P&Z CASE # SP2022-040 P&Z DATE August 9, 2022 CC DATE N/A Approved/Denied

PROJECT NUMBER: SP2022-040
PROJECT NAME: Site Plan for John King Office Park
SITE ADDRESS/LOCATIONS: 1940 N JOHN KING BLVD

CASE CAPTION: Discuss and consider a request by Jeff Carroll of Carroll Architects, Inc. on behalf of Aaron Davis of SBM Real Estates Services for the approval of a Site Plan for an Office Park on a 2.36-acre tract of land identified as Tract 1-2 of the W. H. Baird Survey, Abstract No. 25, City of Rockwall, Rockwall County, Texas, zoned Planned Development District 10 (PD-10) for Commercial (C) District land uses, situated within the SH-205 By-Pass Overlay (SH-205 BY-OV) District, located on the west side of John King Boulevard south of the intersection of John King Boulevard and SH-276, and take any action necessary.

DEPARTMENT	REVIEWER	DATE OF REVIEW	STATUS OF PROJECT
PLANNING	Henry Lee	07/22/2022	Needs Review

SITE PLAN

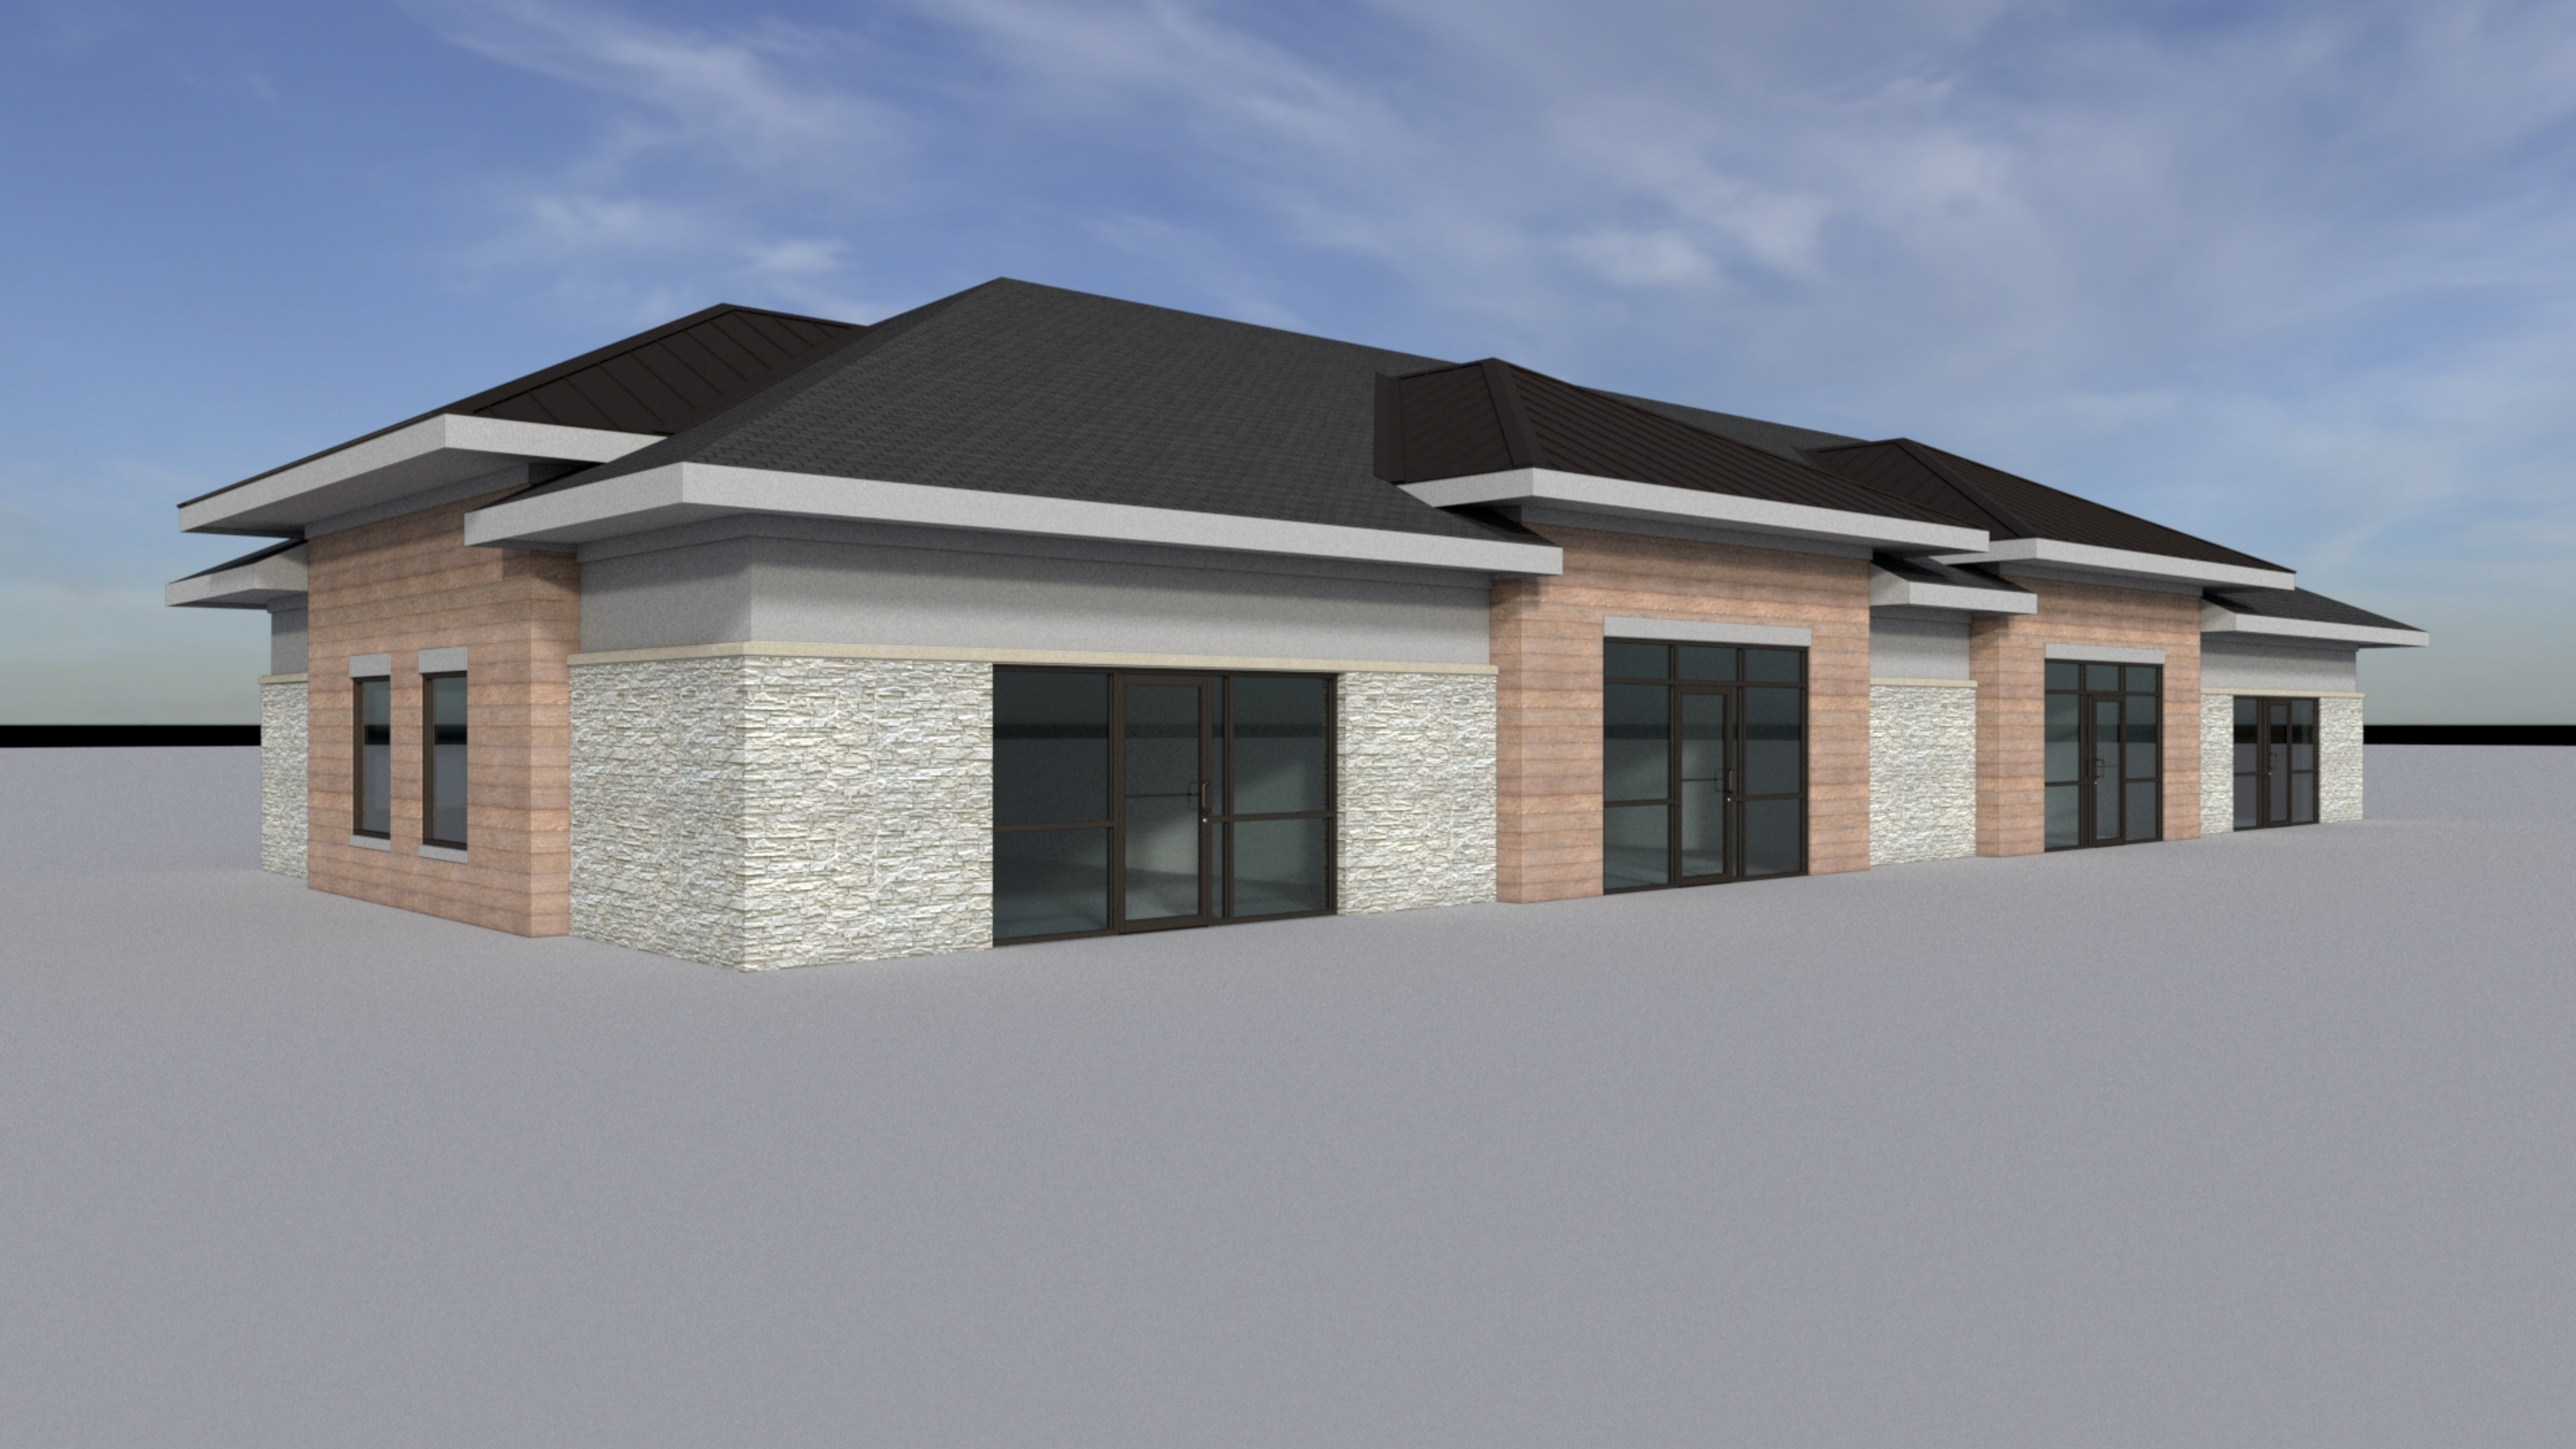
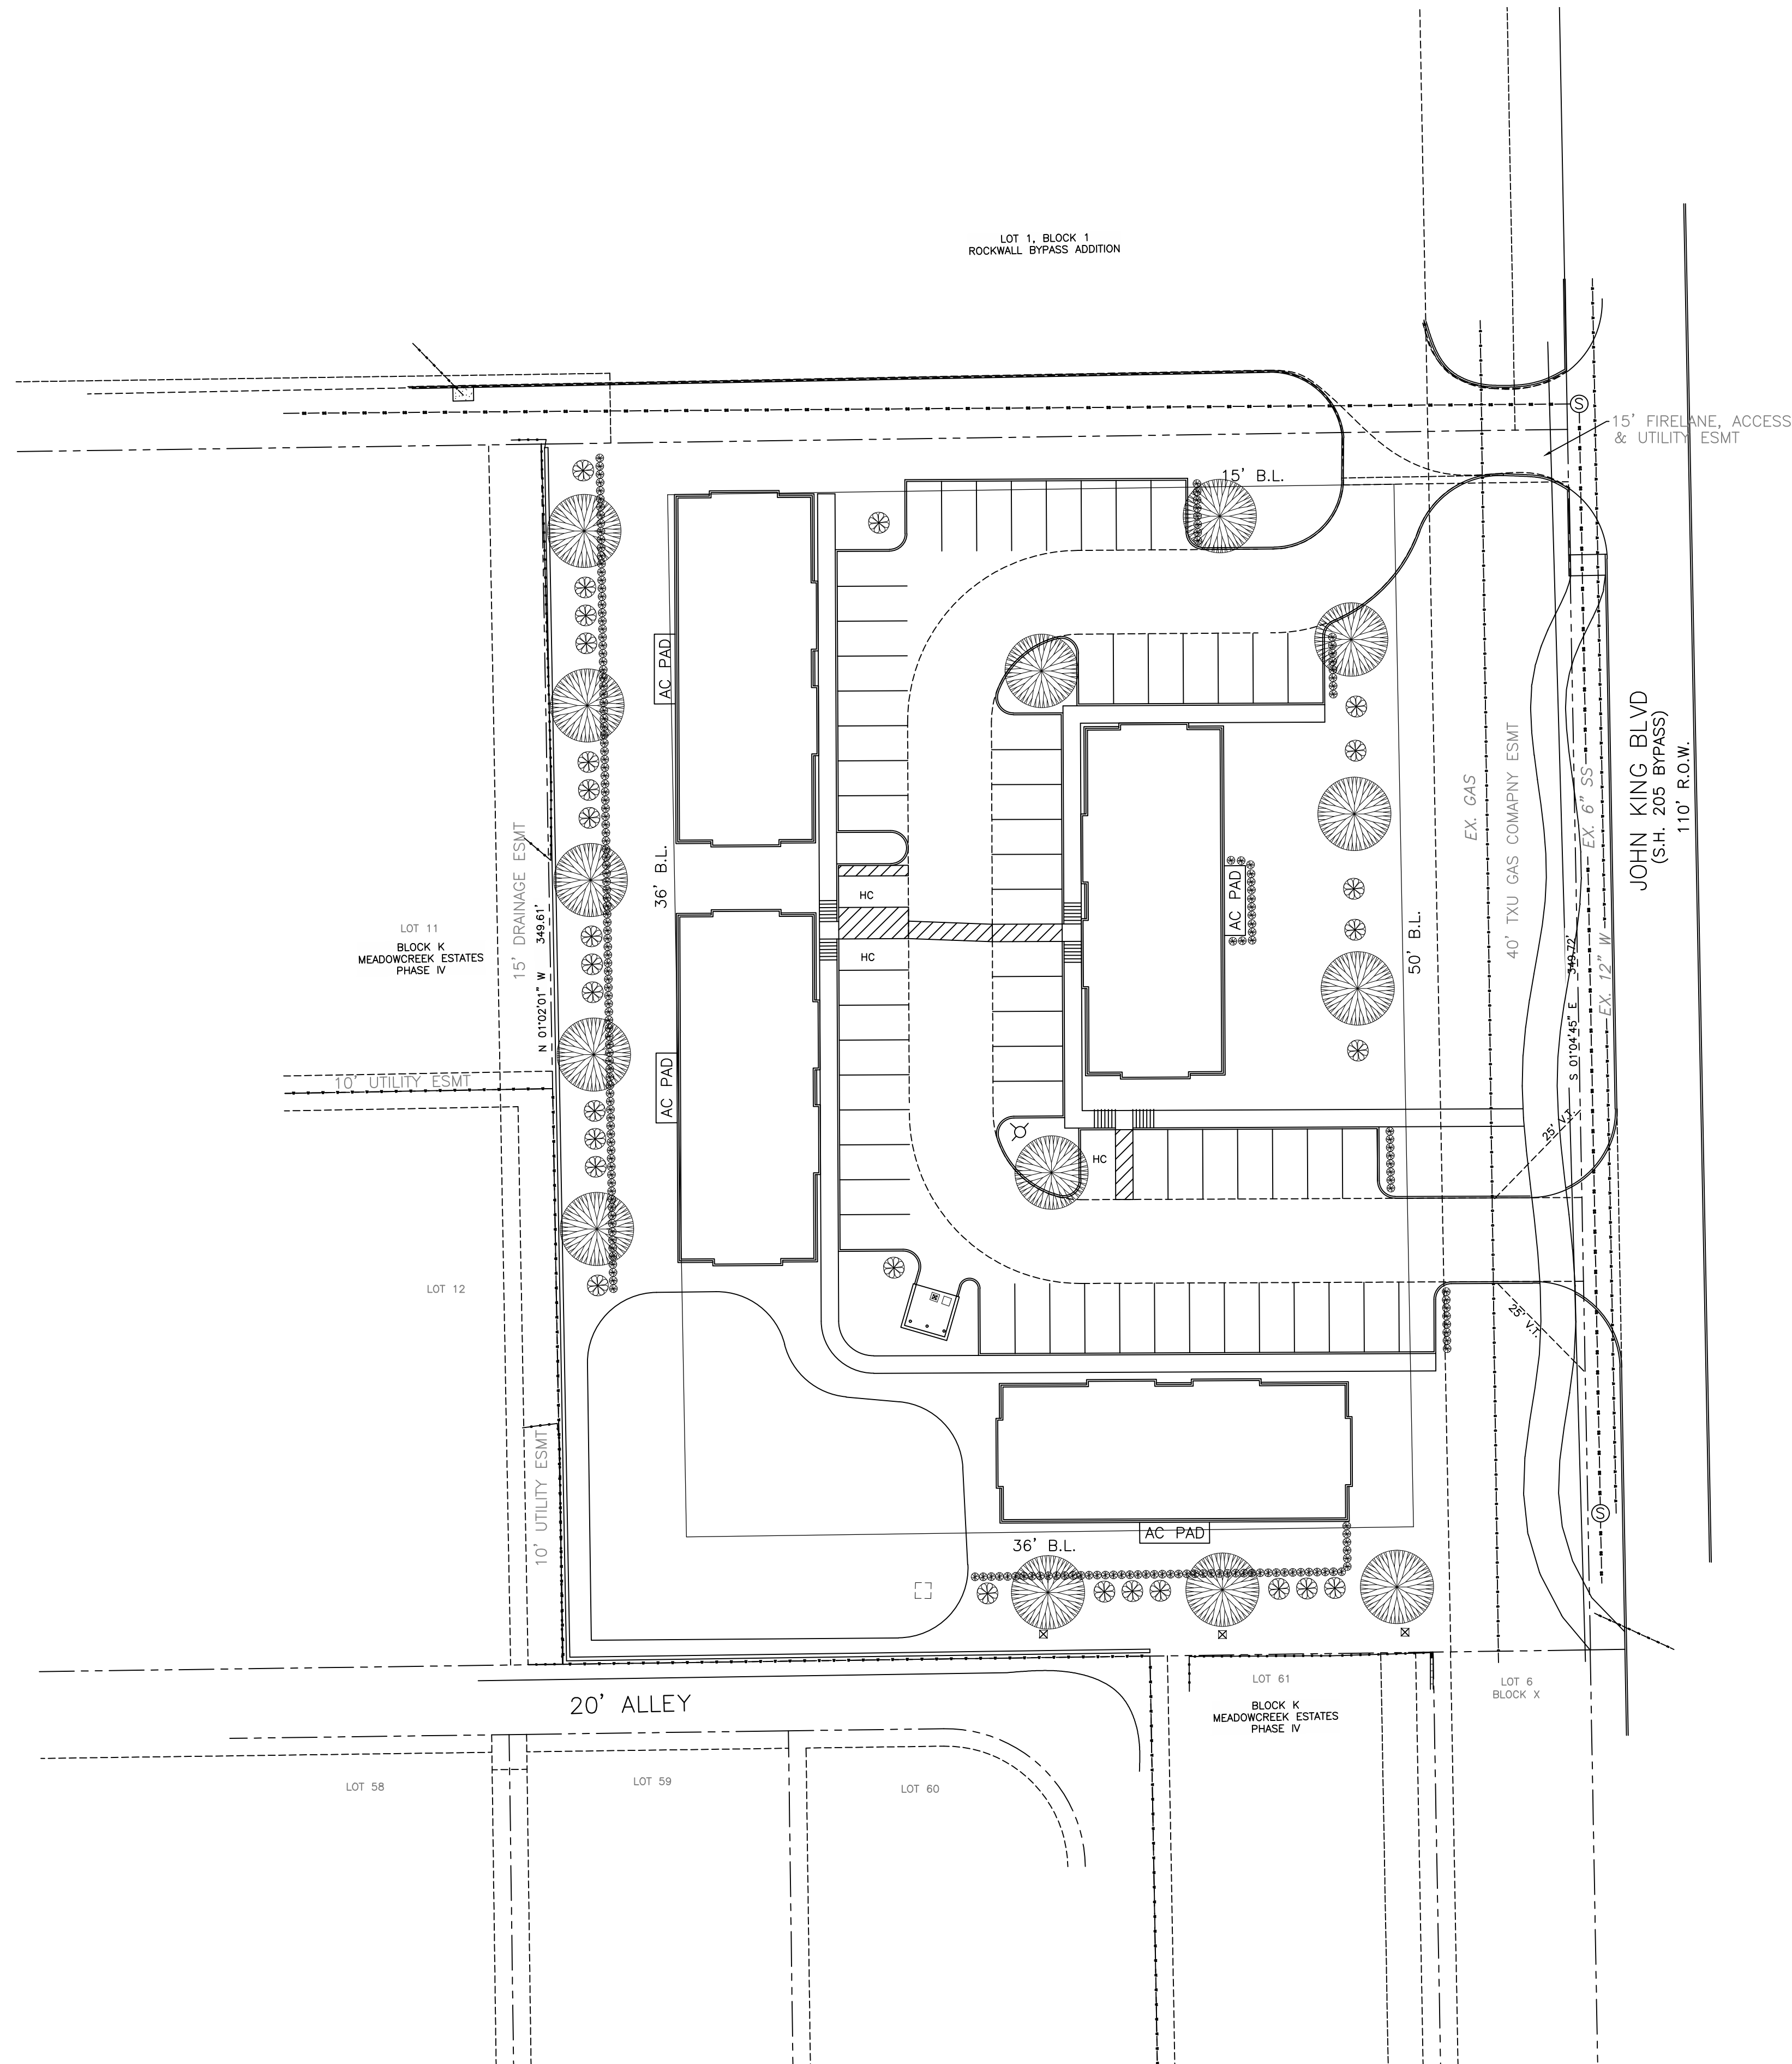
M.9 Site Plan:

1. Please provide the dimensions of the site. (Subsection 03.04. B, of Article 11)
2. The front setback is 50-feet, the north side setback is 10-feet, and the south and west side setback is 20-feet. (Subsection 03.04. B, of Article 11)

5. Signage is covered in a separate permit. (Subsection 06.02. F, of Article 05)
6. Indicate the height and type of all fencing existing and proposed. Provide a detail of the residential adjacency screening. (Subsection 08.02. F, of Article 08)

7. No outside storage will be permitted.
8. All ground mounted utility equipment must be screened from all Right-of-Way and adjacent properties. In this case at the middle building move the pad units to the south side of the building, at the south building fully screen pad units with shrubs, and the rear buildings plant shrubs on the sides of the pad units. (Subsection 01.05. C, of Article 05)

9. Dumpster Screening. The masonry screening wall must be 12-feet by 10-feet, and 8-feet in height because the property is located in an overlay district. The gate must be self-latching and not manual. The dumpster enclosure must be faced in the same material as the primary building. The enclosure must have 5-gallon shrubs planted around it. Please provide a detail. (Subsection 01.05. B, of Article 05)

07/18/2022: Label proposed fire lane on the site plan.
